Service Letter No. 508

Subject: Propeller Counterweight Attachment Bolt Clearance

Models Affected: PA-31, PA-31-300 Navajos

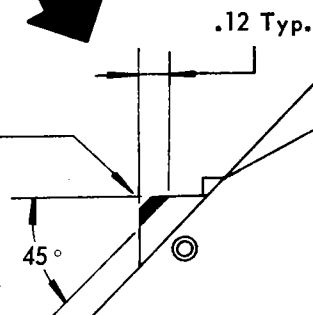
Instructions: If evidence of bolt scoring in the spinner is detected, the bolt head must be reworked per the Hartzell approved rework procedure as illustrated on the sketch on the reverse side of this letter.

Remove this amount of material from bolt head if necessary.
Paint surface with metal primer or equivalent protective paint.

The maximum allowable depth of scoring by the propeller counterweight attachment bolt in the propeller spinner shall not exceed .010 inch. If this dimension is exceeded, the spinner must be replaced. Propeller spinner scoring of .010 inch or less must be dressed out to relieve any stress concentration areas.
